Howard County Health Department

APPLICATION

FOR PERCOLATION TESTING AND SITE EVALUATION

PROPERTY LOCATION
SUBDIVISION/PROPERTY NAME WELLINGTON LOT NO. 9

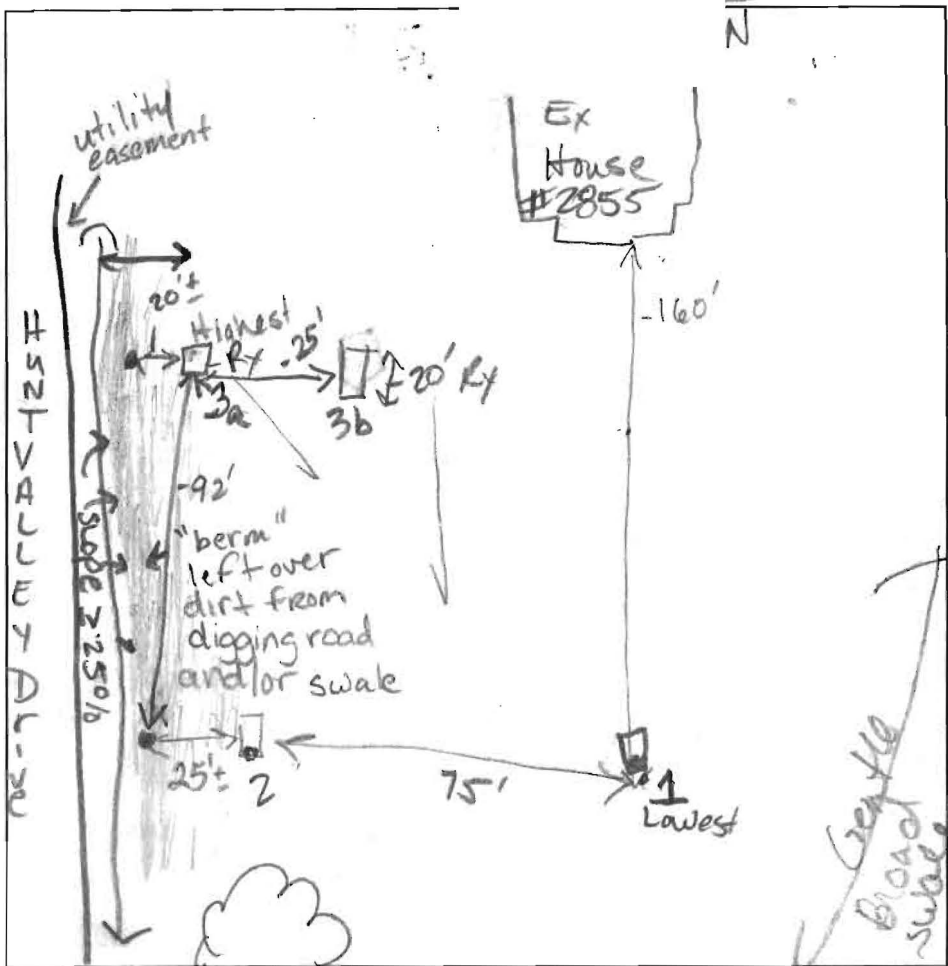
AGENCY REVIEW: 4-14-04 Relocate SDA for future DATE 4/15/2004

Jennis court proposal; 10/1 Not avail ld #225.00

DATE	TEST #	DEPTH	START	BREAK 1" DROP	STOP 2" DROP	TIME OF 2nd INCH	P/F/H	
4/20/04	①	3 1/2'	8:37	9:10	No moil		F	
	②	Dug 1/2 on fill & 1/2 on natural grade. About 1 1/2 - 2' fill on natural grade.						
		4 1/2' S	8:54	8:59	9:08	10	OK	
	③	27' from 25% slope	Rock vein running N-S 7' from stake move 25"					F
	④	Rock veins @					F	
	NEED TO FIELD LOCATE HOLES AND PROPOSE A 10' AREA. NEED ATTL TESTING

Proposal
REMARKS Relocate SDA for tennis court permit
SANITARIAN Kacie BACKHOE Bill Baker OTHERS _____
TEST HOLES USED IN SDA _____ AVG. PERC TIME _____ SQ. FT/BR _____
TRENCH WIDTH N/A INLET DEPTH _____ MAX. BOT DEPTH _____ EFFECTIVE SW _____

RELOCATION OF SDA for TENNIS Court Not AN OPTION

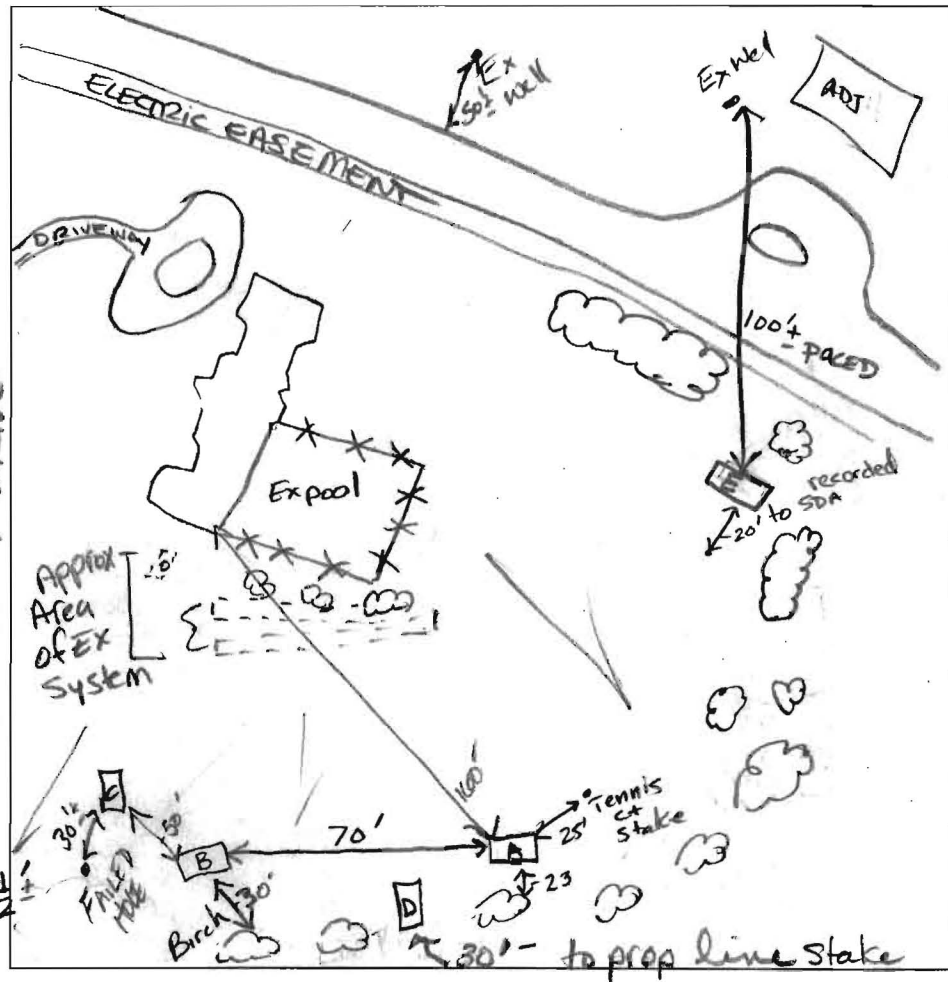
DATE	TEST #	DEPTH	START	BREAK 1" DROP	STOP 2" DROP	TIME OF 2nd INCH	P/F/H	
6/23/04	(A)	5'8"	8:40	9:24	Tip of 2nd peg just touching	10:18 30' peg just touching	~ 60 min Bottom 13'	
	(B)	5'5'	8:59	9:17	9:53 Just touching base of peg	> 30 min		
	(C)	5'5'	2.5 gal 9:12	9:36 2/3	WATER still sitting	F		
	(D)	SEE SOIL Profile					F	
	(E)	PASSES ~ 20'-25' to perc hole #3 from P						
		5/11/88 Notes with 4 min perc rate by B. Nixon						
		Proposed Tennis Court 10' from EDGE OF SDA.

6/23/04 Additional percing led to holes
A-D failing. Hole E, at highest elevation
and 100' downslope of AD, wells confirmed
B. Nixon's perc results. MAY Adjust SDA slightly
towards SE corner of property.

* Awaiting new revised plan with holes
identified as dug & location of tennis
court.

WAITING for new site plan w/ approved
tennis court location & perc test results
indicating location of holes passed/failed.

O.K. w/ results. Maintain setbacks
to SDA before approving but, you
know that!
